Mobile Intel® Celeron® Processor at 466 MHz, 433 MHz, 400 MHz, 366 MHz, 333 MHz, 300 MHz, and 266 MHz Specification Update

Release Date: August 2002

Order Number: 244444-035

H29. Thermal Sensor May Assert SMBALERT# Incorrectly

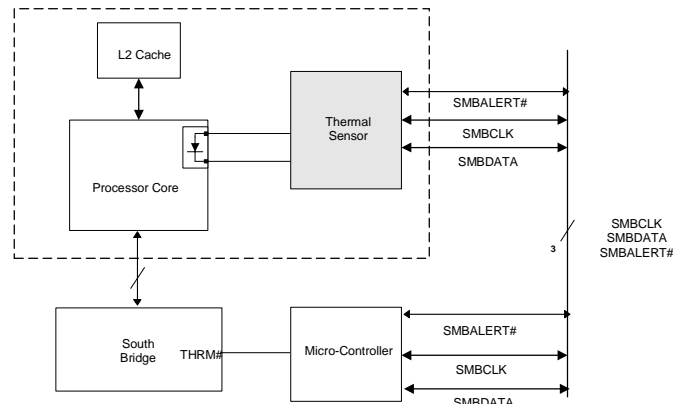
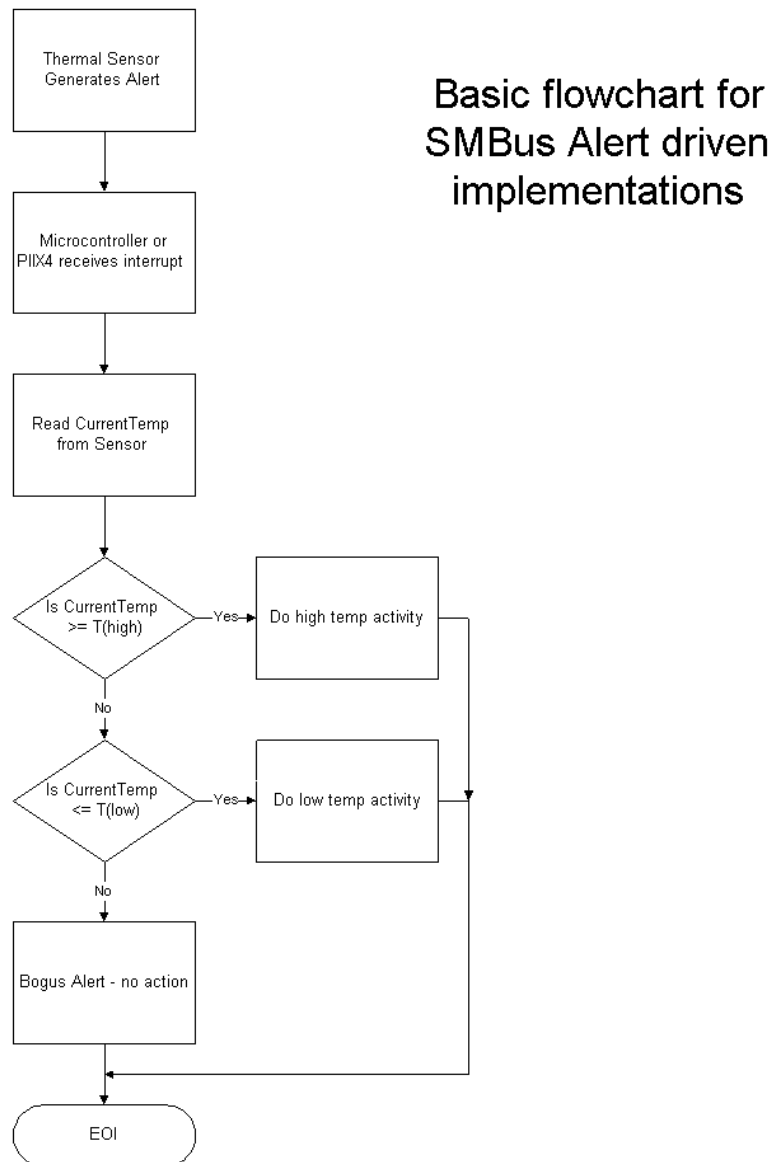
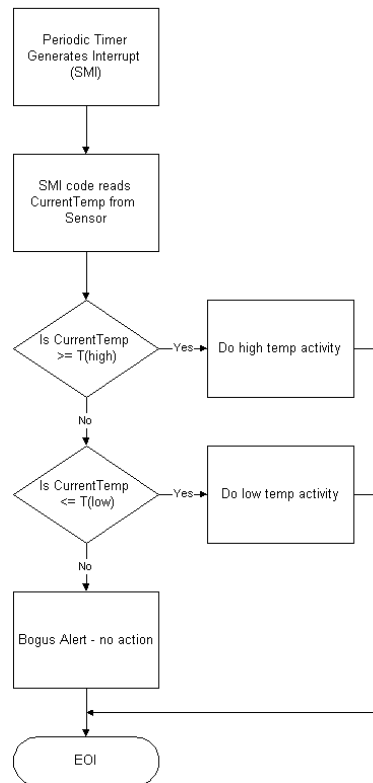
Problem: The Intel Celeron Processor Mobile Module has a thermal sensor that monitors the processor core's temperature. Please note that desktop systems could have a similar thermal device. The thermal sensor asserts SMBALERT# if the processor temperature exceeds the temperature limits set in the Alarm Threshold Registers (T_{HIGH} , T_{LOW}). It also sets the corresponding Status Register bits to identify the cause of the interrupt. Figure 1 gives one example of the how the SMBALERT# signal could be used in a system.

Implication: There is no system impact from this erratum if temperature polling is used for processor thermal management. If the SMBALERT# interrupt is employed to manage processor thermal sensing, then servicing the false interrupt may result in premature system action depending on the software and hardware implementations used. The rate of the false interrupts is less than the auto-convert rate of the thermal sensor.

Workaround: Three different (mutually exclusive) workarounds are possible:

1. Before servicing an interrupt from the thermal sensor, read and compare the processor thermal reading with the threshold limits (T_{HIGH} or T_{LOW}). Figures 2 and 3 provide basic flowcharts for the implementation of this workaround in an interrupt driven system.
2. If the firmware implemented polls the Status Register only, then before taking any action, re-read the temperature register and do a comparison with the alarm threshold limits (T_{HIGH} or T_{LOW}) to determine if the value is actually still within the temperature window.
3. Use a temperature polling scheme to monitor the processor temperature.
